LIDL GREAT BRITAIN LTD
OLDLANDS FARM
BOGNOR REGIS

SURFACE WATER DRAINAGE,
CONDITION 6 RE-SUBMISSION

Report Reference:	LIDLBOGNOR.10-DTN
Project Code:	SF/LIDLBOGNOR.10
Prepared by:	SF
Approved by:	PA
Issue Date:	October 2024
Status:	1st Issue

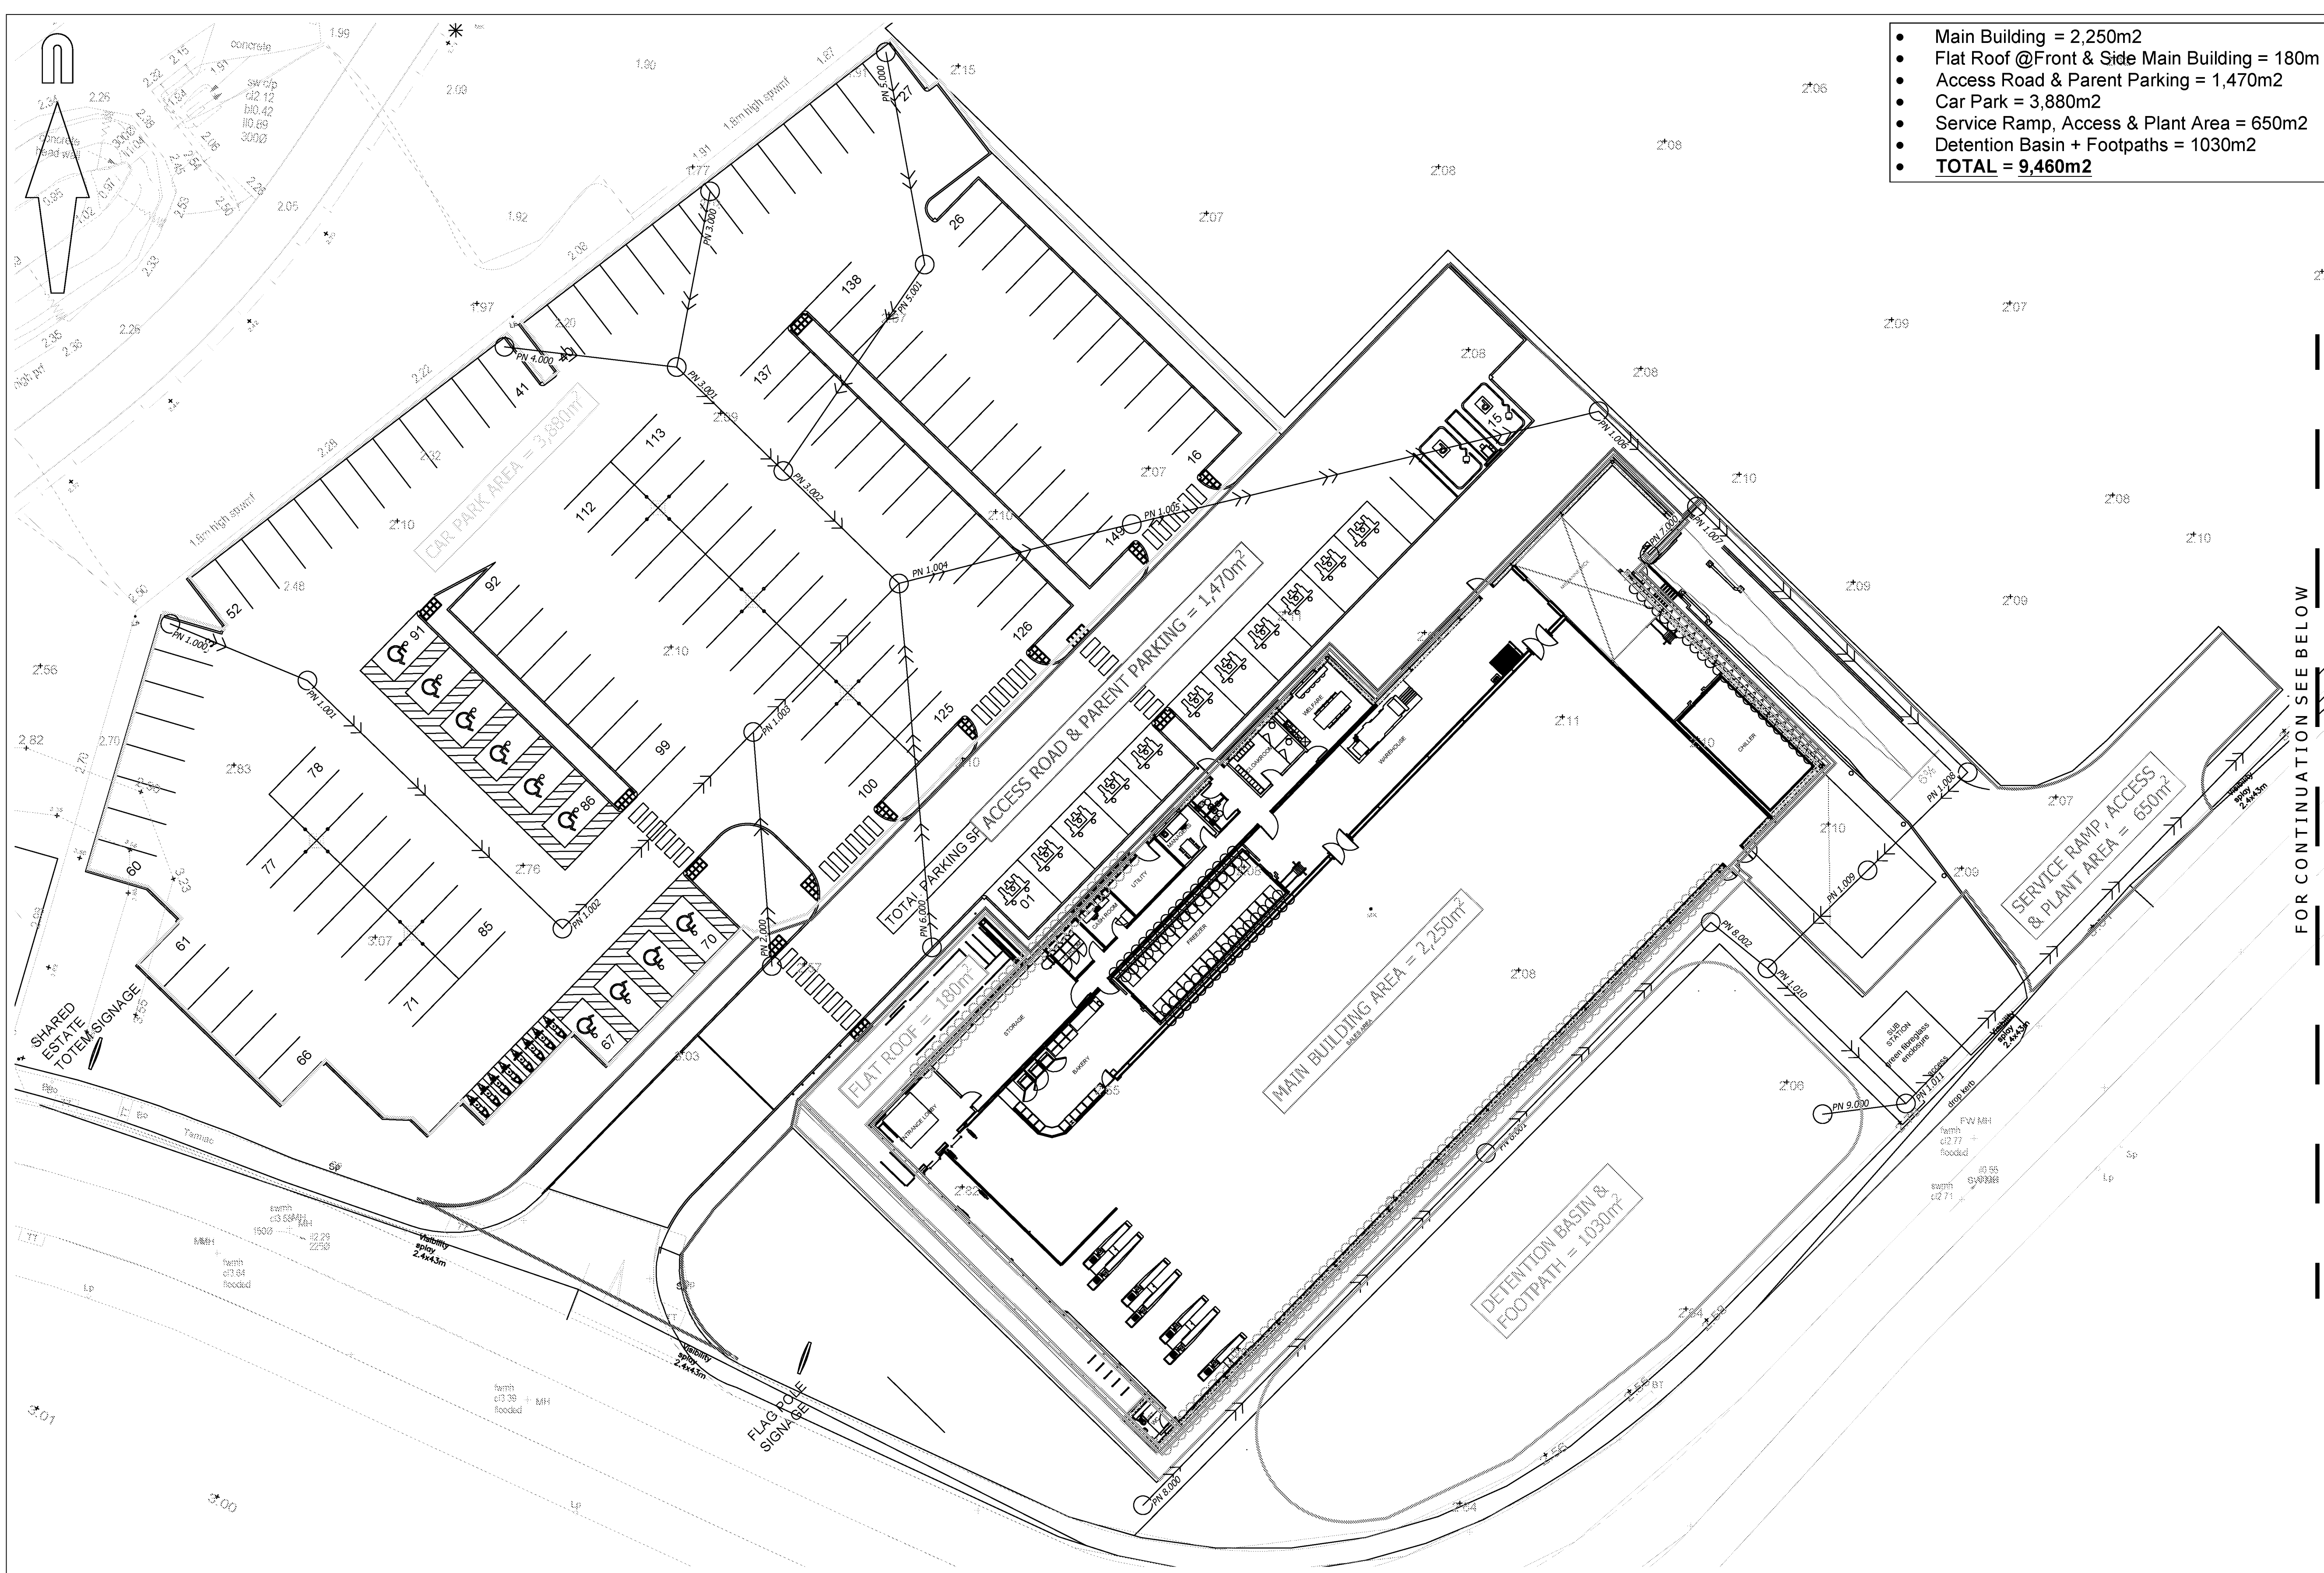
1. Car park levels have been constructed nearly 1m lower than the approved design. Modelled surface water flood depths are over 400mm. As per CIRIA C635 car park flooding should be kept to an absolute maximum of 200mm. Furthermore, ADEPT guidance is clear that flooding over 300mm is not suitable in vehicular areas. We therefore request that the applicant re-designs and eventually re-constructs some areas to ensure that flooding is reduced and kept to moderate depths only, i.e. less than kerb level.
2. Calculated impermeable area for the revised design appears to be substantially less than the approved design. Please detail catchment areas on plan, and explain where this reduction in impermeable area has been achieved.
3. There are several inconsistencies between calculations and layout including the outfall, hydrobrake and pond.

4. With the level of information provided it is difficult to verify the storage volume modelled at the delivery ramp, greater levels information is required.
5. The verification report does not meet the requirements of this condition. Please see our verification condition guidance note which details the information which is required to discharge this condition, this document can be found here: <https://www.arun.gov.uk/drainage-planning-consultations>,
